Process Sheet

Customer	: CU-DAR001 Dart Helicopters Services		Drawing Name	: MIRROR BRACKET
Job Number	: 36919			
Estimate Number	: 10142			
P.O. Number	:		Part Number	: D2161204
This Issue	: 1/23/2008	S.O. No. :	Drawing Number	: D2161 REV B2
Prsht Rev.	: NC		Project Number	: N/A
First Issue	: / /	Type : SMALL /MED FAB	Drawing Revision	: B2
Previous Run	: 36886		Material	:
Written By	:		Due Date	: 1/30/2008 Qty: 5 Um: Each

WORK ORDER CHANGES

WORK ORDER NON-CONFORMANCE (NCR)

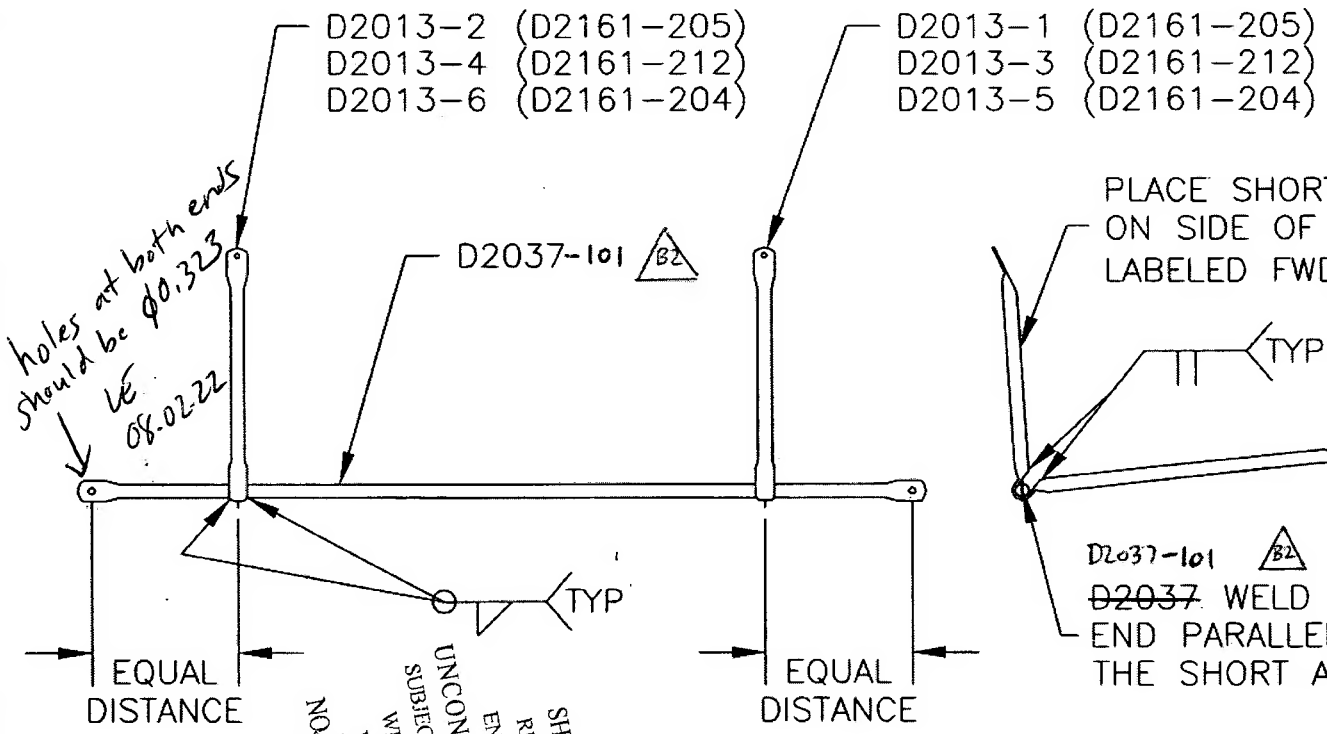
| NCR:			Corrective Action — Section B					
DATE	**STEP**	**Description of NC** Section A	**Initial** Chief Eng	**Action Description** Chief Eng	**Sign & Date**	**Verification** Section C	**Approval** Chief Eng	**Approval** QC Inspector
08.02.22	4.0	D2037-101 hAs A⌀323 on one side only. Should be 2 ends.	LE 08.02.22	Drill open ⌀.257 →.323. As per hand change on Dwg.	FE 08/02/26	JB 08/02/22	LE 08.02.22	✓ 08.02.22

holes at both ends
should be ⌀0.323
LÉ
08.02.22
